825 NORTH BROADWAY WHITE PLAINS, NY 10603 (TOWN OF NORTH CASTLE)

AUTOMOBILE SERVICE STATION ALTERATION (GAS TANKS REPAIR AND CONVENIENCE STORE INTERIOR ALTERATIONS)

We have revised the plans to answer the May 20, 2022 comments from the Town Consulting Engineering John Kellard, P.E. as follows (**in bold**):

PROPOSED SITE PLAN

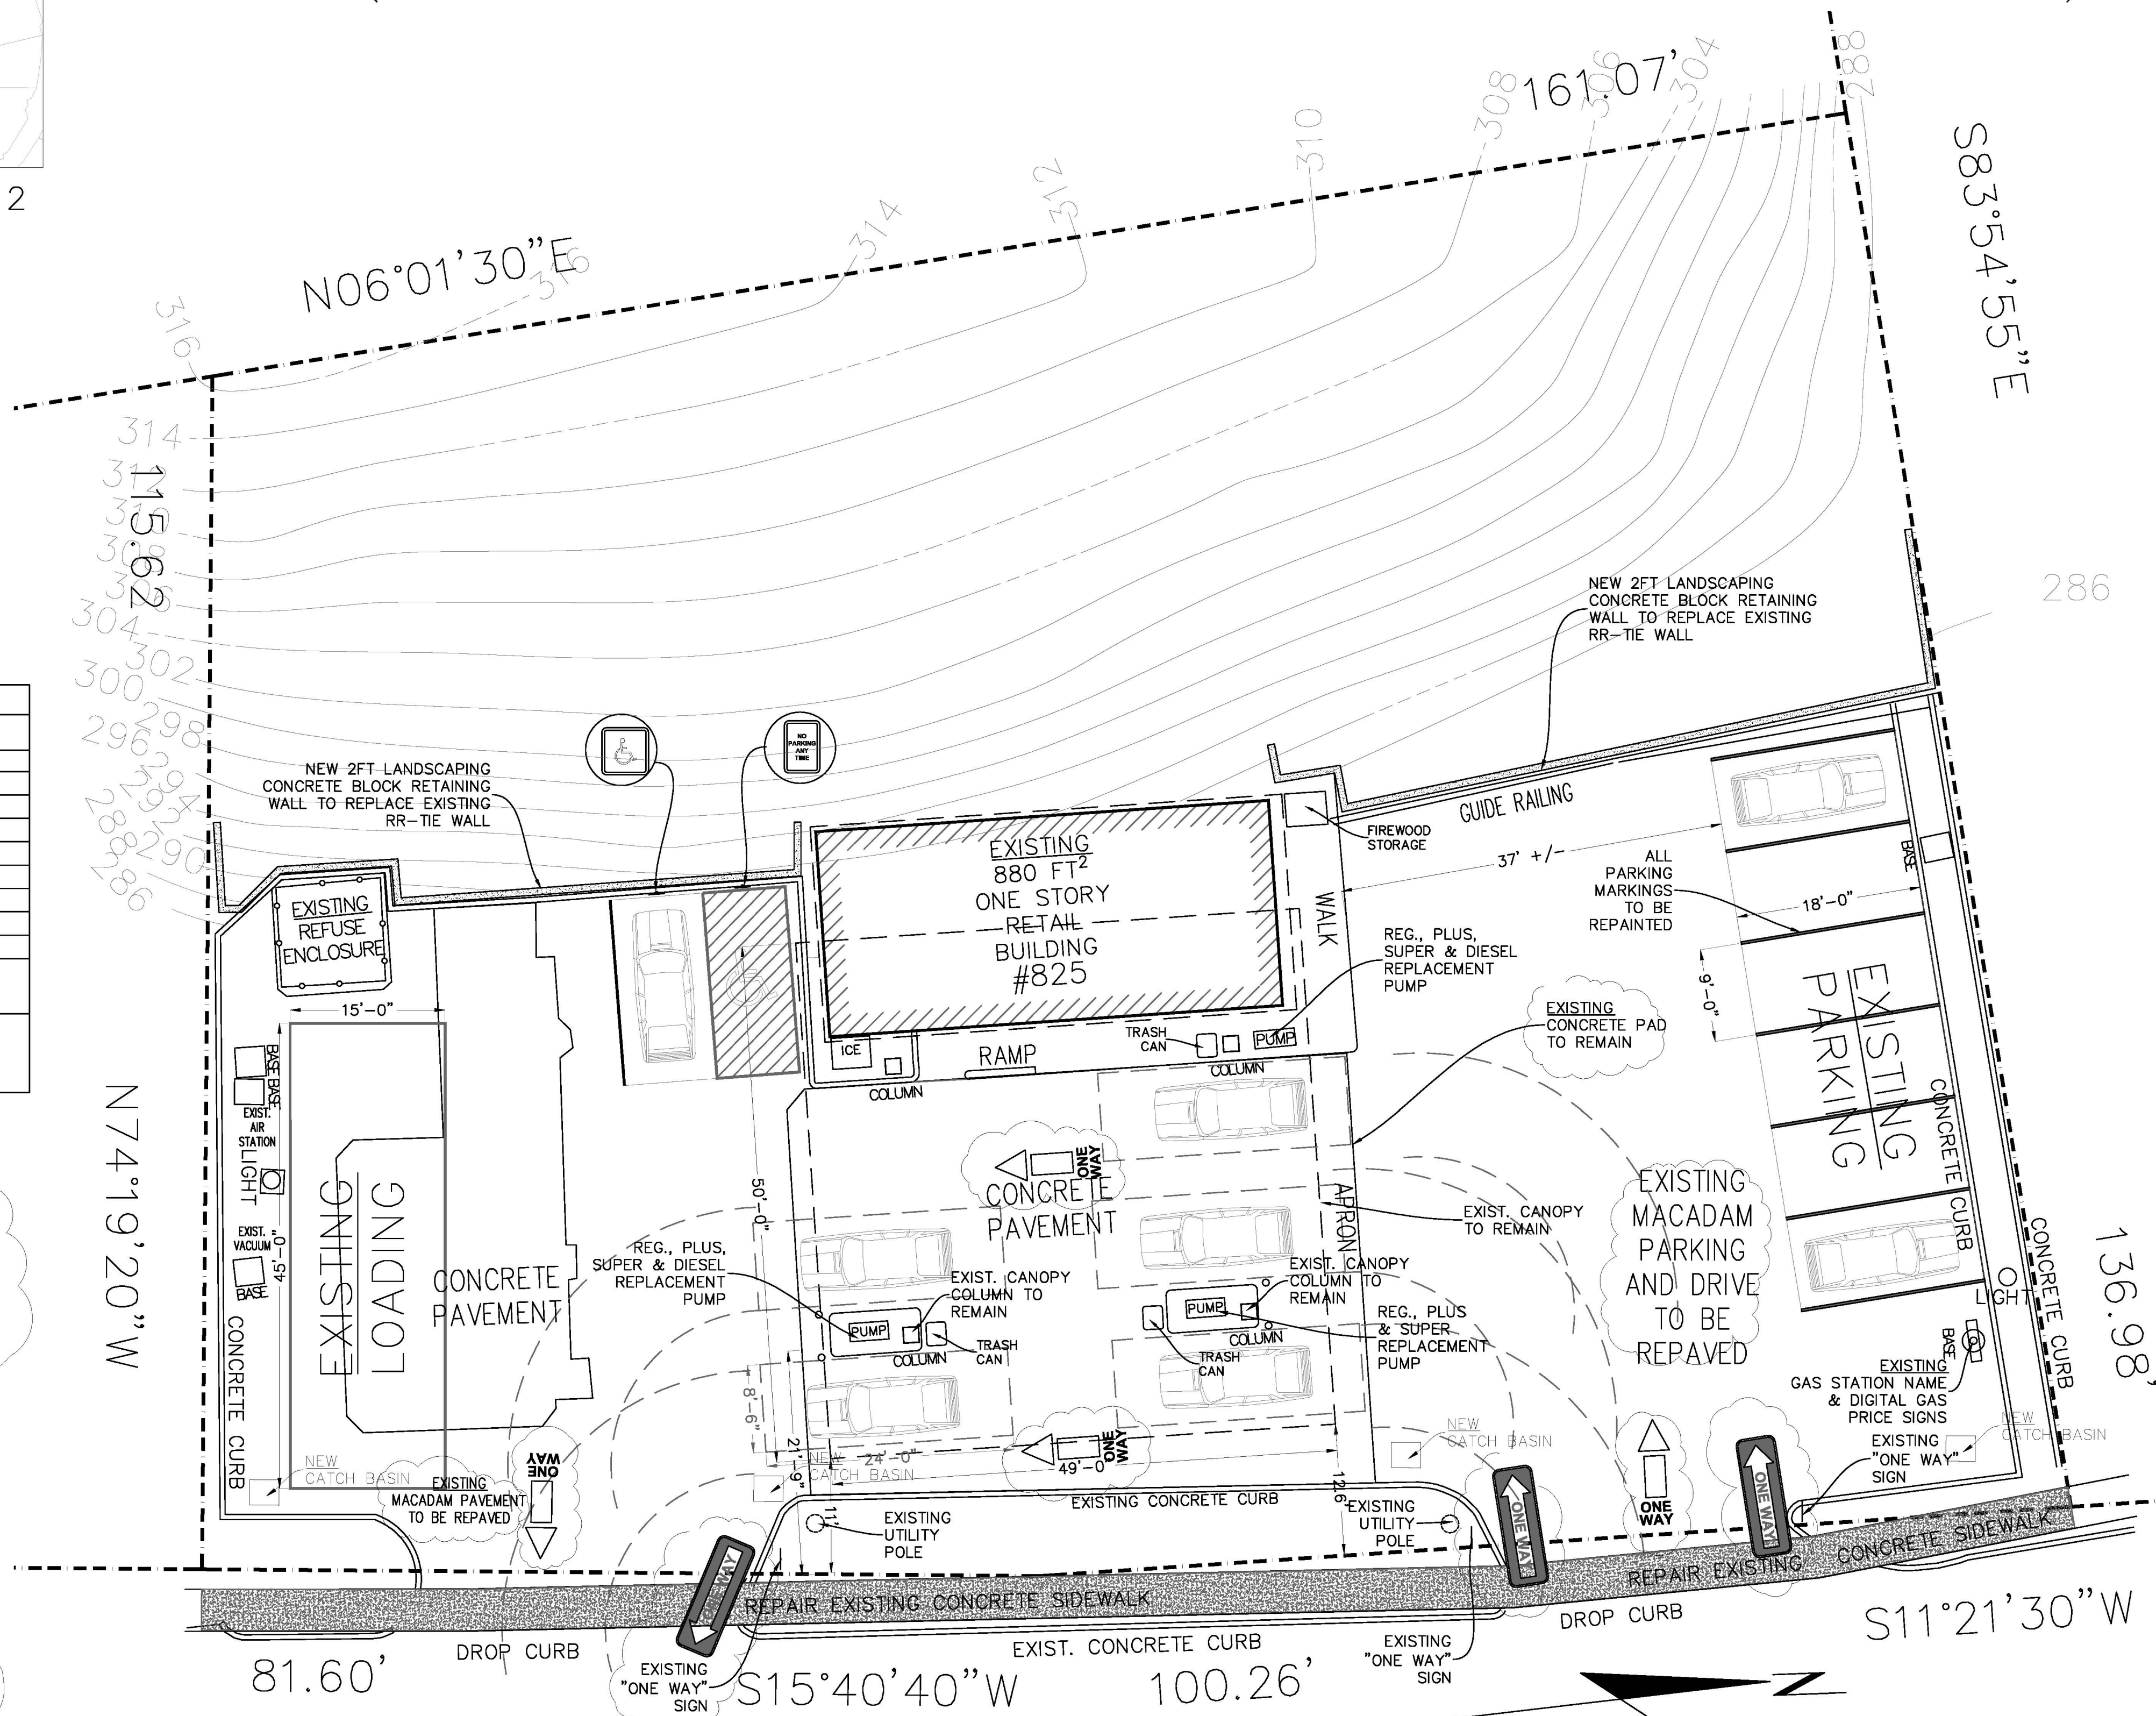
4. The applicant is proposing new concrete drive mats over the new storage tanks and fueling area. The existing asphalt pavement appears to be in need of repair and portions of the asphalt will be further damaged during construction. The applicant should clarify whether they intend to repave the entire asphalt surfaces. Also, damaged concrete curbing should also be repaired and the lot should be re-striped.

2. The existing one-way circulation pattern and signs should be depicted on the site plan

4. The Applicant should take this opportunity to aesthetically improve the design of the building and site. It is recommended that the Planning Board and the Architectural Review Board work closely with the Applicant to maximize quality design standards.

8. The site plan should be revised to contain a note stating that outdoor repair of vehicles shall be prohibited.

Existing asphalt pavement called out as being repaired. Note added on page G1 specifying that the asphalt pavement shall be repaved in its entirety and all marking shall be repainted.

One Way sign illustration and one way road painted marking added to site plan.

Aesthetic Improvement note added on page G1.

Note added on page G1

EXISTING GAS STATION
SCALE: 1" = 10.0'

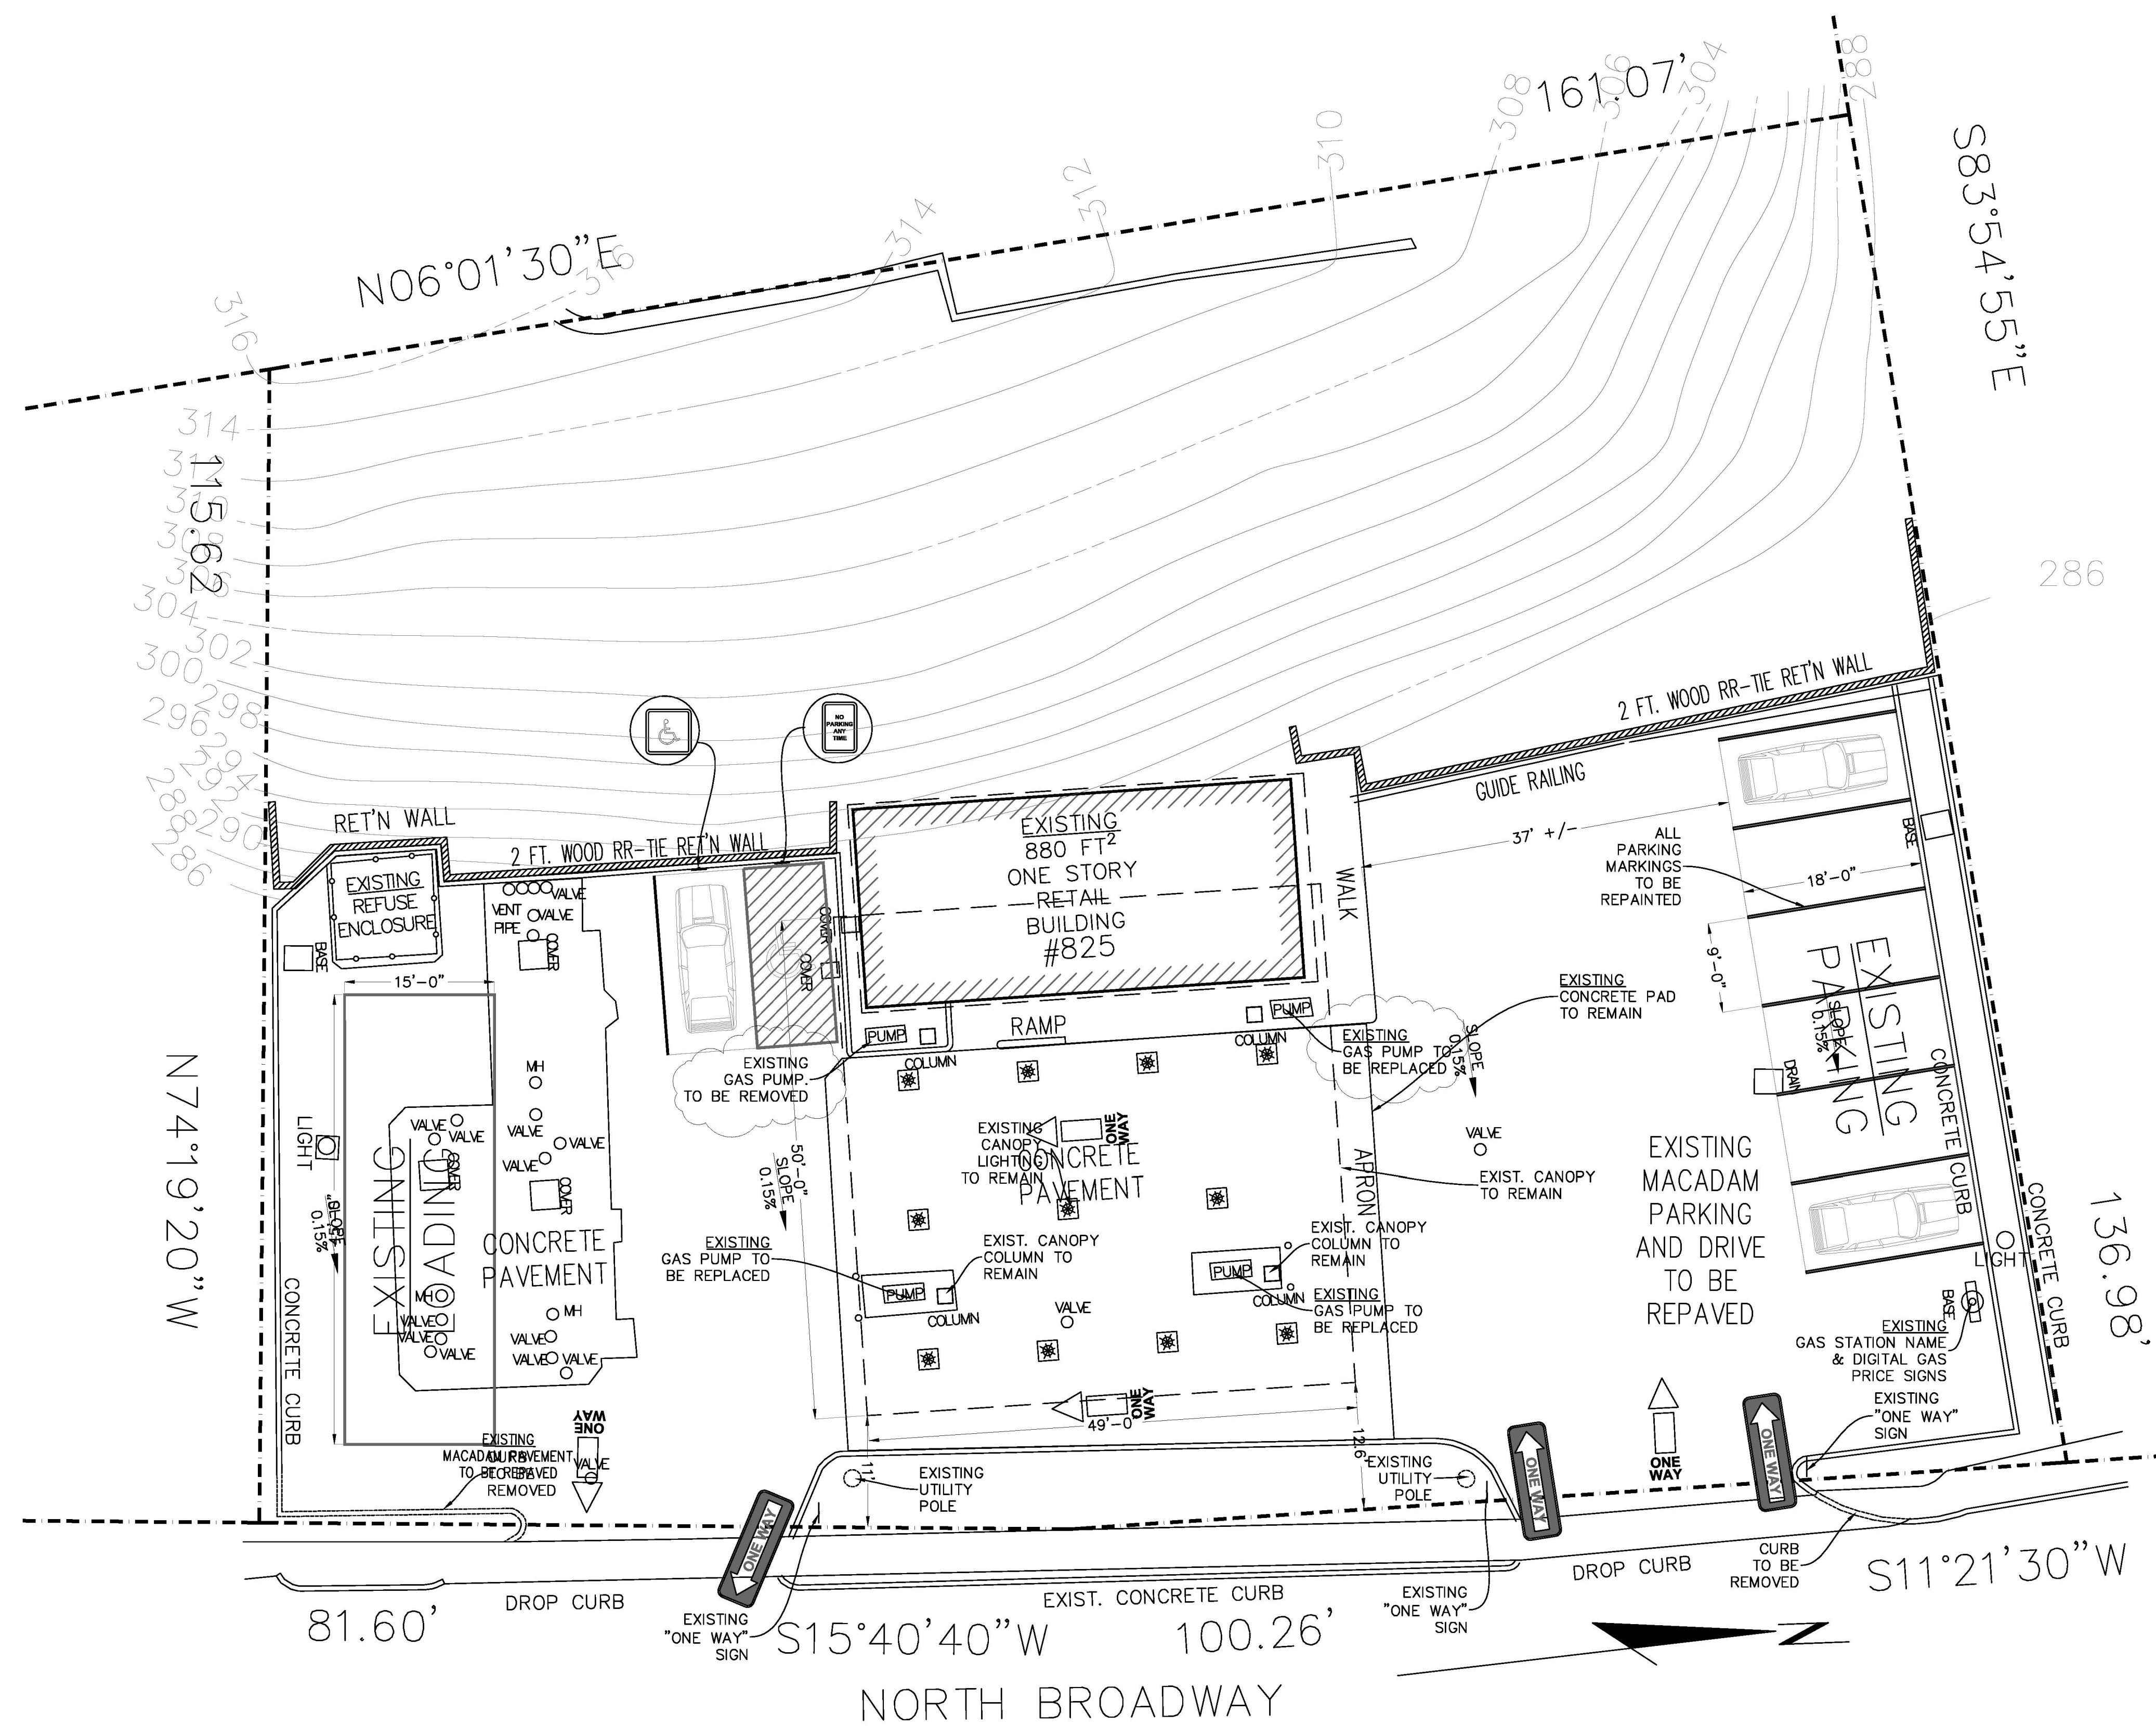
1. The applicant should review Site Plan Sheet G1 and Existing Gas Station Sheet G2. Sheet G2 does not show the existing fuel service pump to remain at the left front corner of the building or the existing pump on the right side of the building to be removed. All plans should be updated for consistency.
